# Product Change Notification

Product Group: Draloric/Beyschlag Resistors /March 8, 2016/PCN-DBR-001-2016 Rev 0

## Thick Film Resistors CRCW0201 Top Conductor Width Change

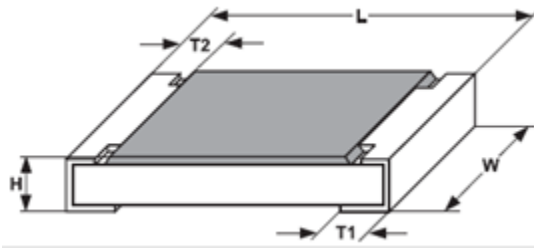
Width of top conductor length (dimension T2 in below drawing) changed from 0.2 +0.05/-0.10 mm to 0.10 ±0.05 mm for CRCW0201.
